DISCUSSION OF CHANGES
ITS 3.6.12, ICE BED

ITS NRC Questions

Id **120**
NRC
Question Number **CSS-026**
Category **Technical**
ITS Section **3.6**
ITS Number **3.6.12**
DOC Number **M-1**
JFD Number
JFD Bases Number
Page Number(s) **508**
NRC Reviewer Supervisor **Select**
Technical Branch POC **Add Name**
Conf Call Requested **N**

FIGURE 7.2.1-1 SHEET 19
FUNCTIONAL DIAGRAMS ENVIRONMENT
ALLOWANCE MOD & TRIP TIME
DELAY LOGIC
(REVISED BY AMENDMENT 13)

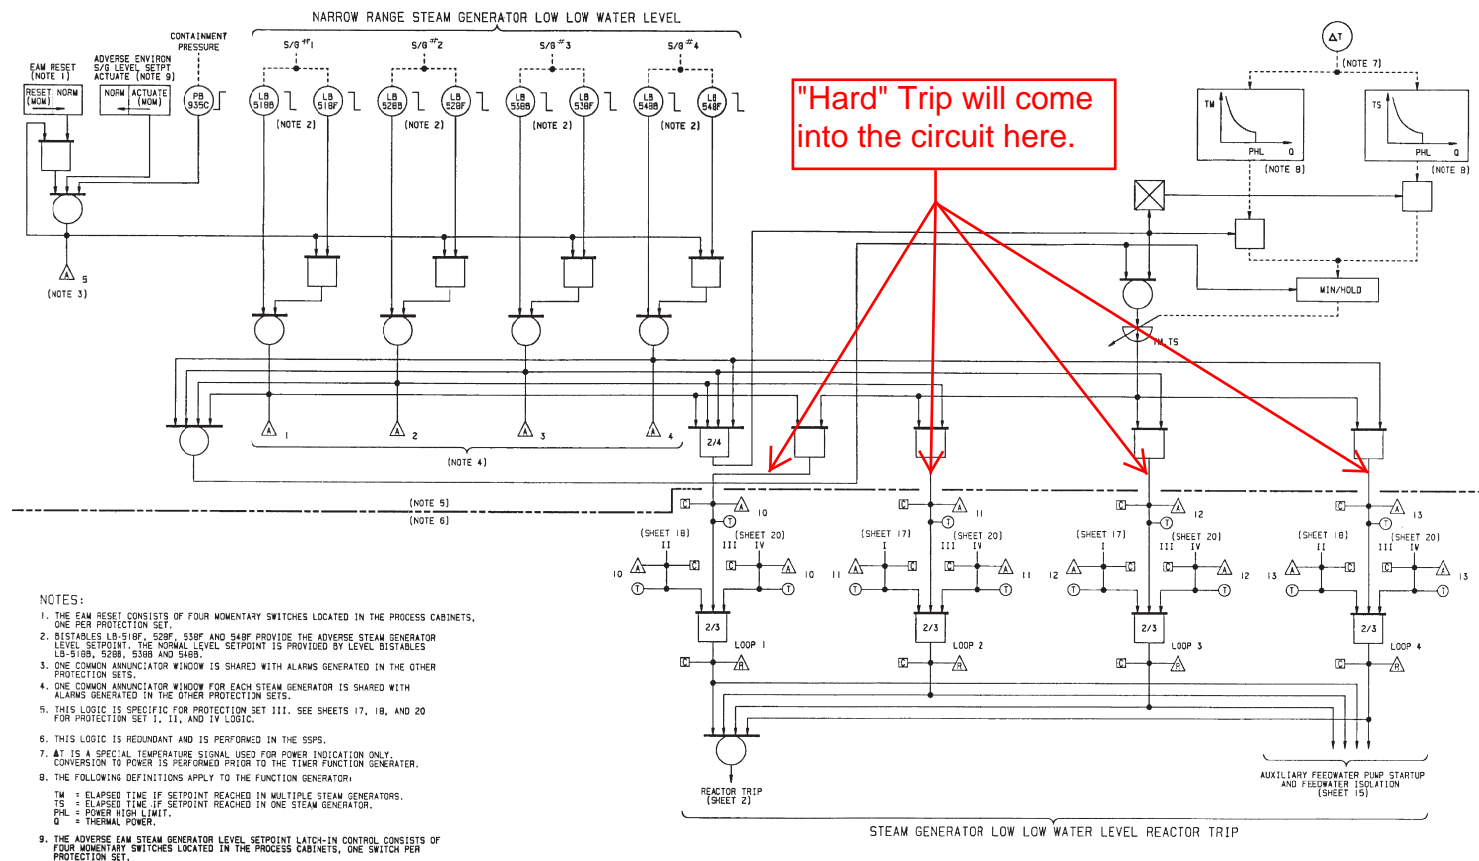
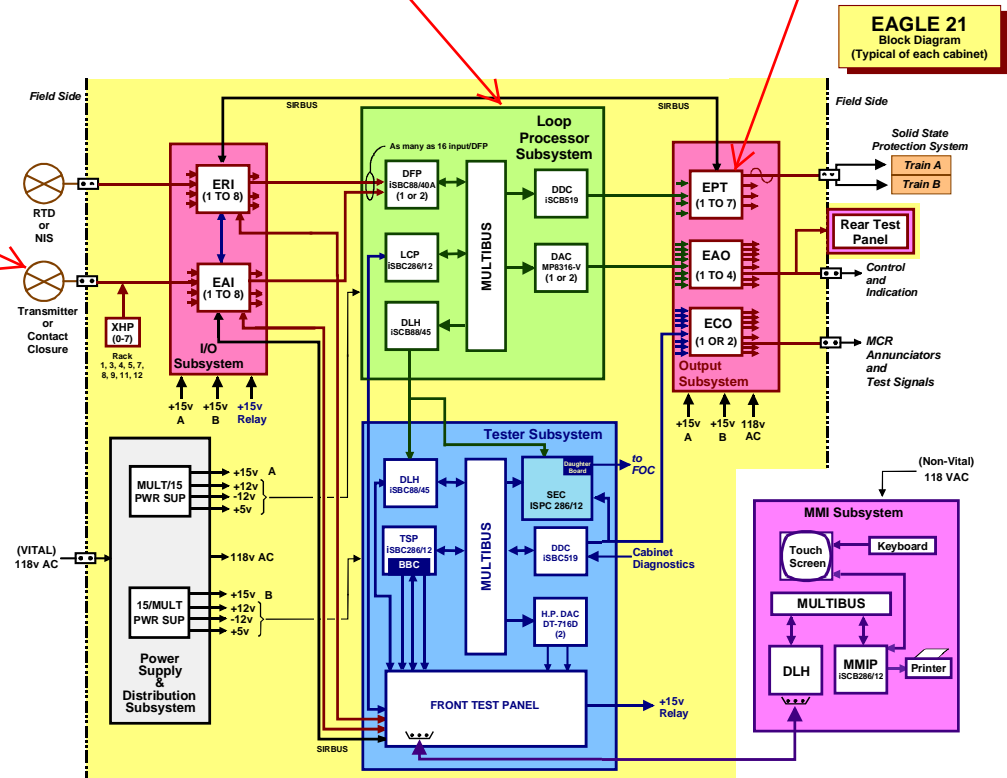
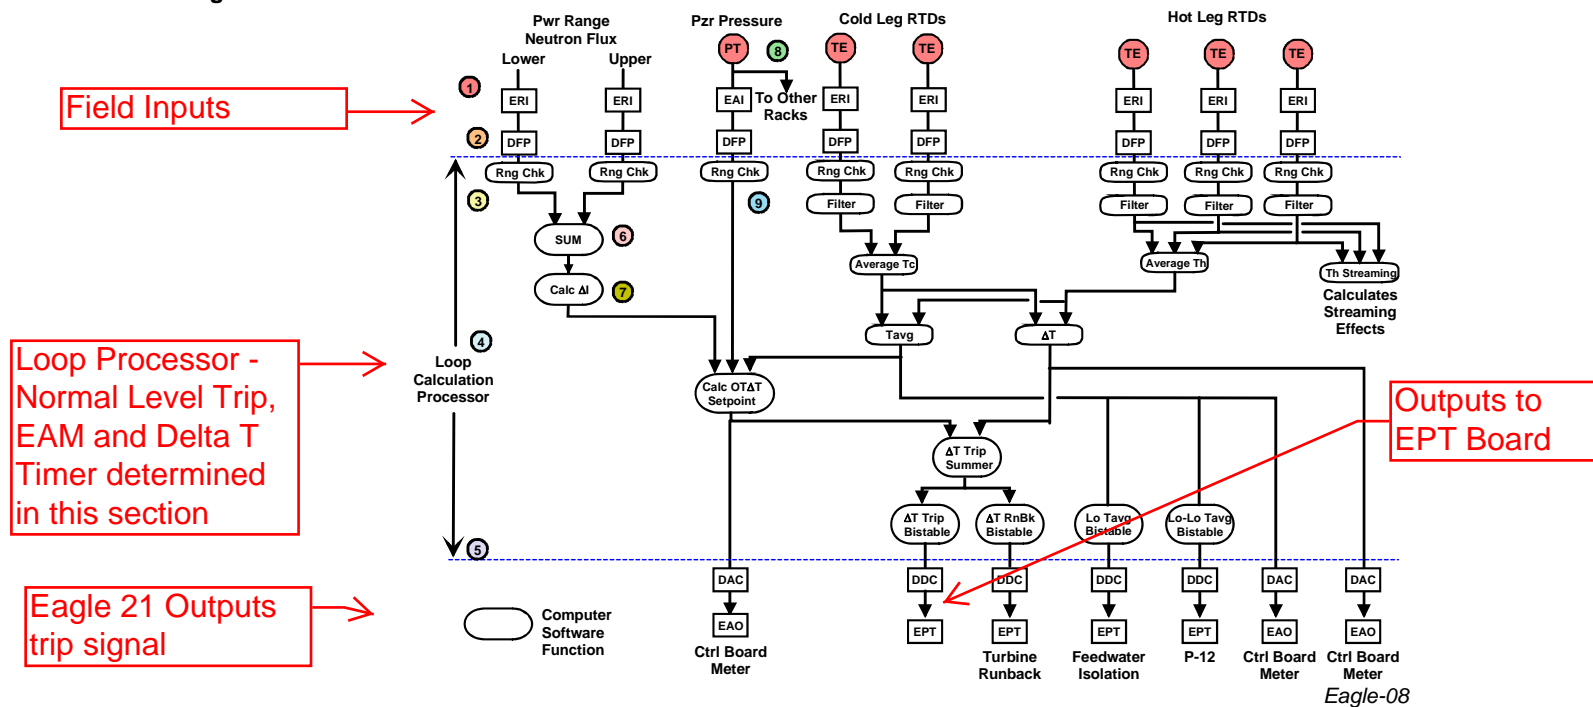
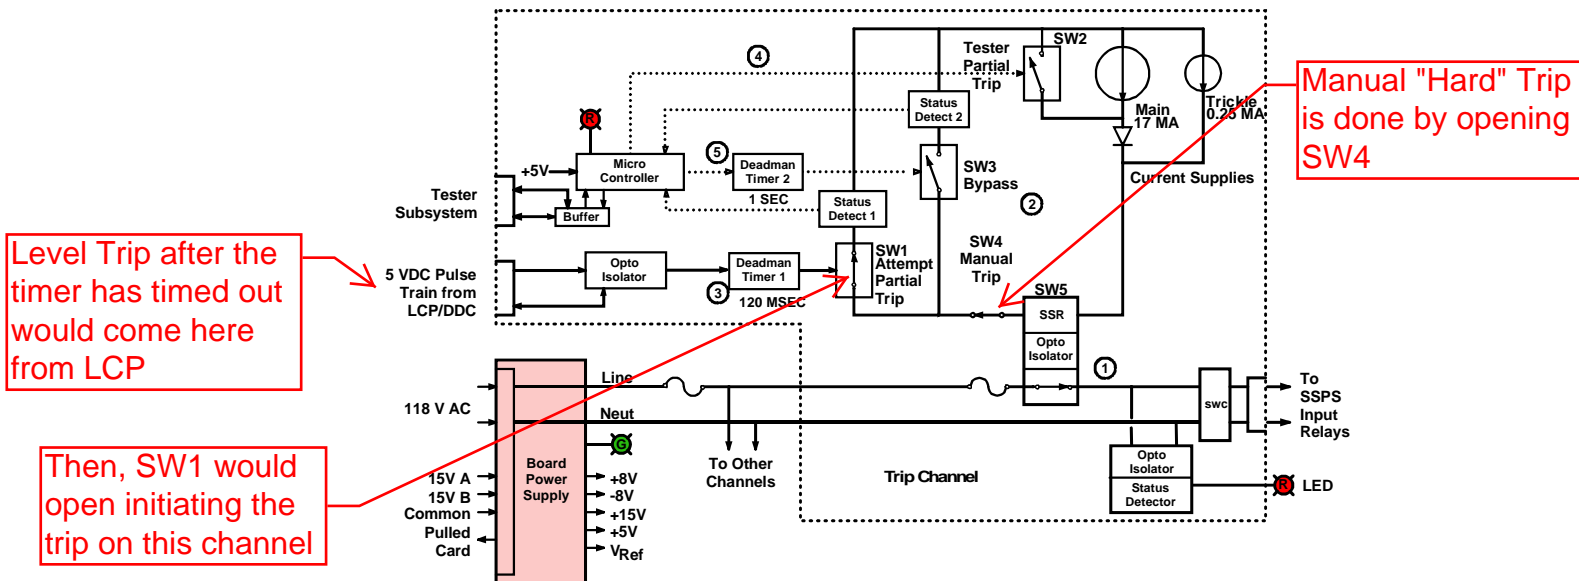
NRC Question **On page 89 of Enclosure 2, Volume 8, L11 provides the discussion of the proposed change that adds required action t.2, which allows placing the affected protection set, steam generator water level low low channel in trip within 6 hours. L12 states, "Once the channel is placed in the tripped condition the RCS ΔT TTD circuitry is removed from the active portion of the Steam Generator Low-Low Level channel, reference UFSAR Figure 7.2.1-1, Sheets 17 through 20 and this action is no longer necessary." Please explain how placing the steam generator low low level channel in trip, removes the RCS ΔT TTD circuitry**

Response Statement	<p>Placing the Steam Generator Low-Low Level Channel in trip does not literally remove the RCS ΔT TTD circuitry from the active portion of the circuit, as stated in the discussion of change (DOC) L11. In the signal flowpath for Steam Generator Low-Low Level Channel trip, the manual trip is downstream of the RCS ΔT TTD input into the Eagle 21 System, thereby negating the RCS ΔT TTD effect on the trip circuit. The RCS ΔT TTD input remains in the circuit, but with the manual trip in place, the RCS ΔT TTD has no effect on the circuit. Therefore, DOC L11 will be revised to replace the sentence, "Once the channel is placed in the tripped condition the RCS ΔT TTD circuitry is removed from the active portion of the Steam Generator Low-Low Level channel, reference UFSAR Figure 7.2.1-1, Sheets 17 through 20 and this action is no longer necessary," with, "Once the channel is placed in the tripped condition, the RCS ΔT TTD input has no effect on the circuit, and these actions are no longer necessary.</p> <p>Attachment 1 contains UFSAR Figure 7.2.1-1, Sheet 19 and the Operations training material associated with the Eagle 21 System. The UFSAR figure depicts the logic for "Automatic" trips and is annotated to show where the manual trip would impact the circuit. The Eagle 21 material illustrates the location of the manual trip within the Eagle 21 System.</p> <p>See Attachment 2 for a draft ITS DOC L11 markup.</p>

FIGURE 7.2.1-1 SHEET 19
FUNCTIONAL DIAGRAMS ENVIRONMENT
ALLOWANCE MOD & TRIP TIME
DELAY LOGIC
(REVISED BY AMENDMENT 13)

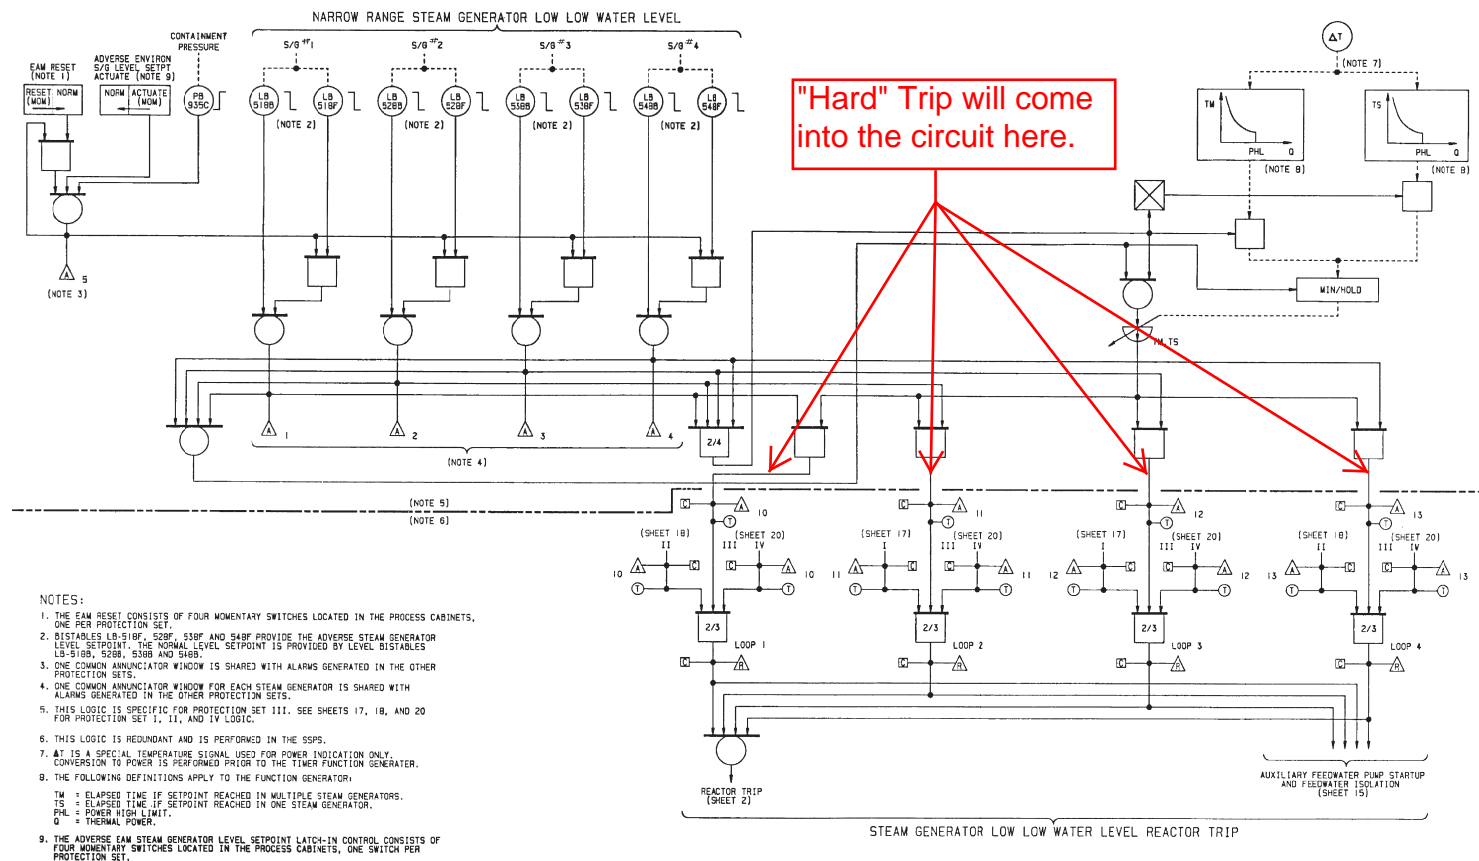
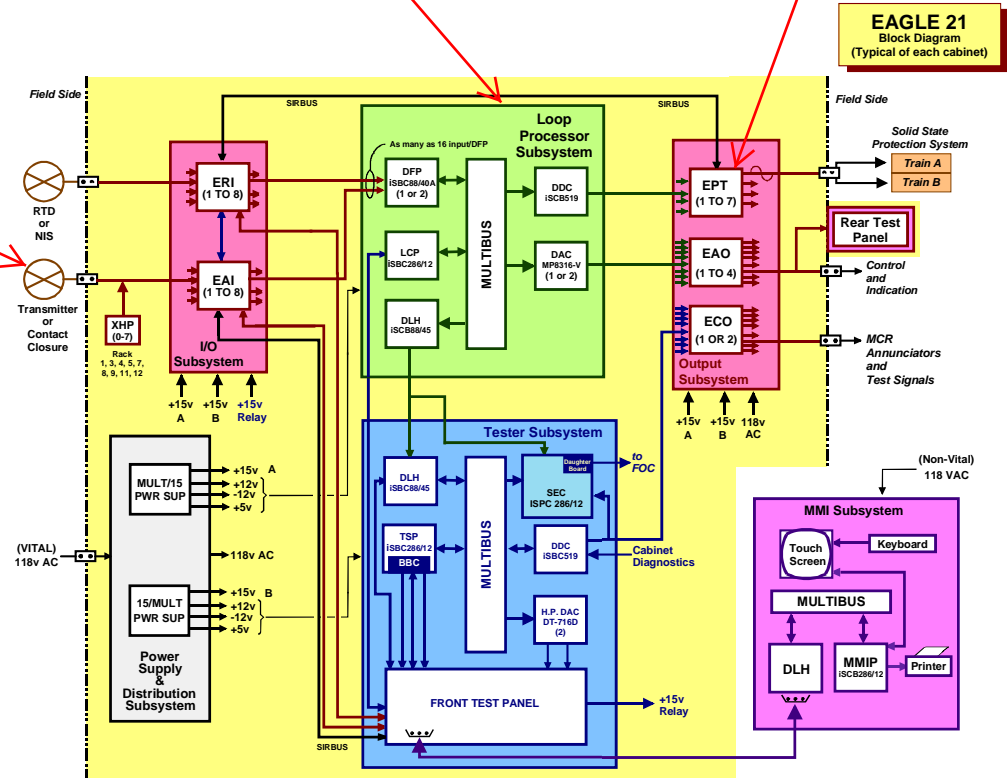
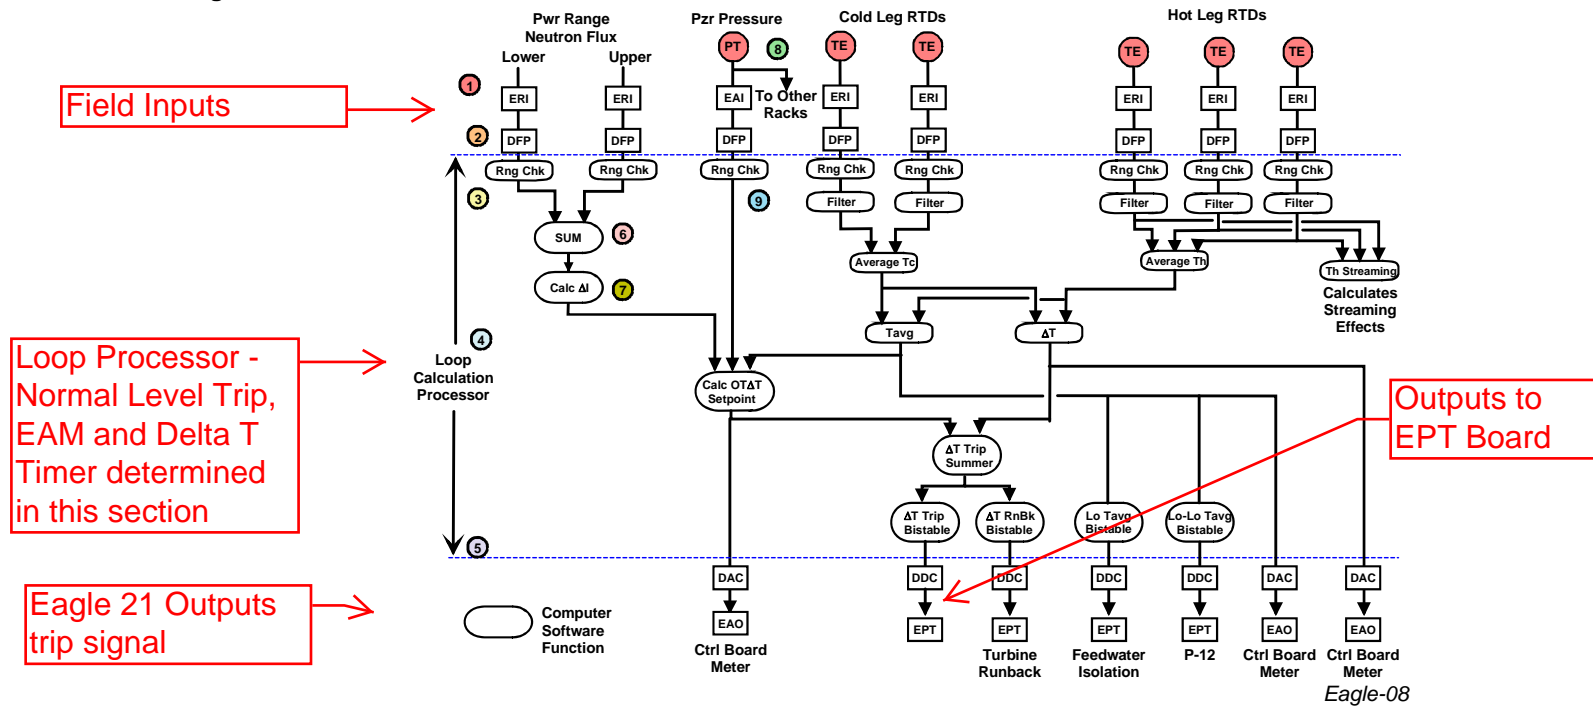
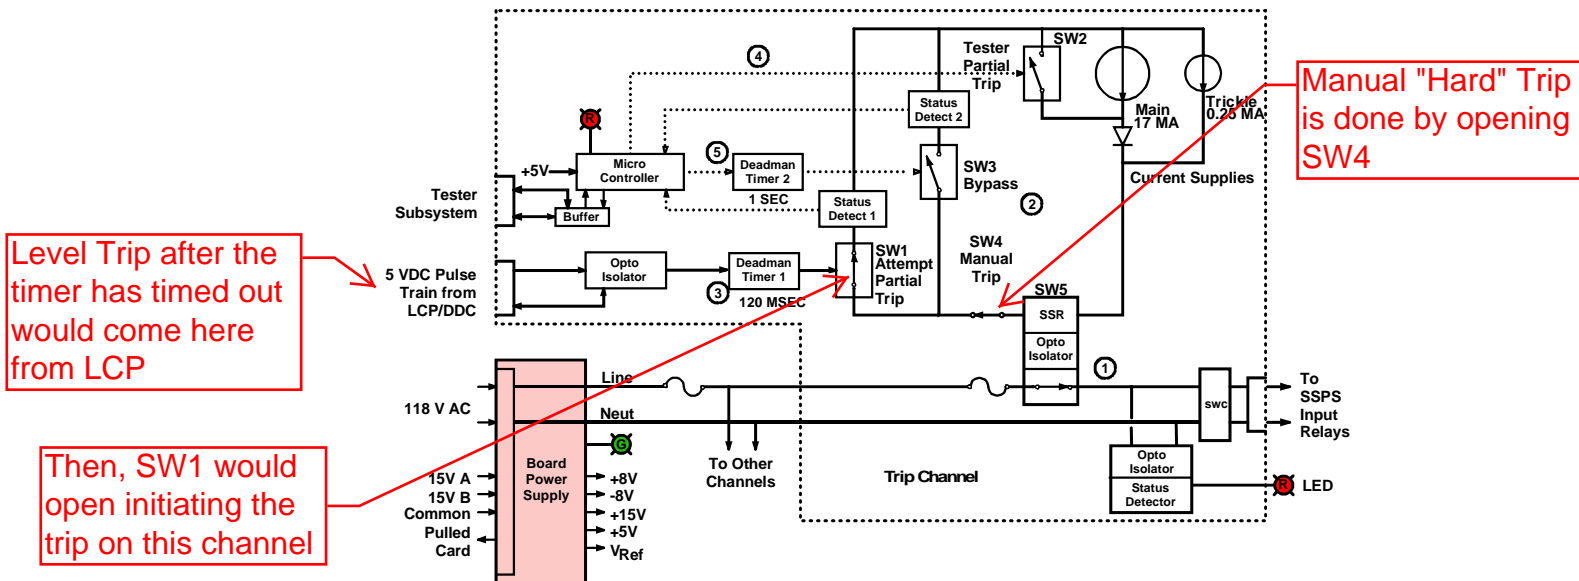
NRC Question **On page 89 of Enclosure 2, Volume 8, L12 provides the discussion of the proposed change that adds required action s.2, which allows placing the affected protection set, steam generator water level low low channel in trip within 6 hours. L12 states, "Once the channel is placed in the tripped condition the Steam Generator Low-Low EAM/Adverse circuitry is removed from the active portion of the Steam Generator Water Level -- Low-Low channel, reference UFSAR Figure 7.2.1-1, Sheets 17 through 20, and these actions are no longer necessary." Please explain how placing the steam generator low low level channel in trip, removes the Steam Generator Low-Low EAM/Adverse circuitry.**

Response Statement	<p>Placing the Steam Generator Low-Low Level Channel in trip does not literally remove the EAM/Adverse circuitry from the active portion of the circuit, as stated in the discussion of change (DOC) L12. In the signal flowpath for Steam Generator Low-Low Level Channel trip, the manual trip is downstream of the Steam Generator Low-Low EAM/Adverse input into the Eagle 21 System, thereby negating the Steam Generator Low-Low EAM/Adverse effect on the trip circuit. The Steam Generator Low-Low EAM/Adverse input remains in the circuit, but with the manual trip in place, the Steam Generator Low-Low EAM/Adverse has no effect on the circuit. Therefore, DOC L12 will be revised to replace the sentence, "Once the channel is placed in the tripped condition the Steam Generator Water Level Low-Low EAM/Adverse circuitry is removed from the active portion of the Steam Generator Water Level Low-Low channel, reference UFSAR Figure 7.2.1-1, Sheets 17 through 20 and these actions are no longer necessary," with, "Once the channel is placed in the tripped condition, the Steam Generator Low-Low EAM/Adverse input has no effect on the circuit, and these actions are no longer necessary."</p> <p>Attachment 1 contains UFSAR Figure 7.2.1-1, Sheet 19 and the Operations training material associated with the Eagle 21 System. The UFSAR figure depicts the logic for "Automatic" trips and is annotated to show where the manual trip would impact the circuit. The Eagle 21 material illustrates the location of the manual trip within the Eagle 21 System.</p> <p>See Attachment 2 for a draft ITS DOC L12 markup.</p>
